# UNITED STATES PATENT AND TRADEMARK OFFICE

APPLICATION NO.	FILING DATE	FIRST NAMED INVENTOR	ATTORNEY DOCKET NO.	CONFIRMATION NO.
10/820,080	04/06/2004	Paul Ciccone	SYNT-0237	7100
53443 7590 10/27/2008 WOODCOCK WASHBURN LLP CIRA CENTRE, 12TH FLOOR 2929 ARCH STREET PHILADELPHIA, PA 19104-2891				
EXAMINER RAMANA, ANURADHA				
ART UNIT		PAPER NUMBER		
3775				
MAIL DATE		DELIVERY MODE		
10/27/2008		PAPER

### Office Action Summary

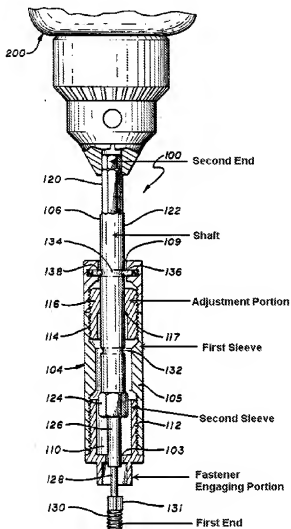
Claims 1-2, 5-7, 38-39, 41-42 and 47 are rejected under 35 U.S.C. 102(b) as being anticipated by Lemke et al. (US 5,255,485).

Lemke et al. disclose an adjustable tool including: a shaft (122, 116) with calibration markings (132, 134); a cutting portion 130, i.e. a portion capable of cutting into material; a fastener engaging portion 102; an adjustment portion 116; and an adjustment mechanism including a first sleeve 105 and a second sleeve 112 mounted on the shaft wherein the cutting portion and the fastener engaging portion can be rotated at different speeds with respect to one another (Figs. 4 and 5, col. 6, lines 47-68, col. 7 and col. 8, lines 1-2). See marked up Fig. 5 from Lemke et al. below.

The Lemke et al. device is fully capable of performing the stated function, "wherein when a cannulated fastener.....distally beyond the fastener tip." It is the Examiner's position that if a suitably sized cannulated fastener is placed

on the fastener engaging portion 102, the distal cutting tip 130 is capable of extending distally beyond the fastener tip.
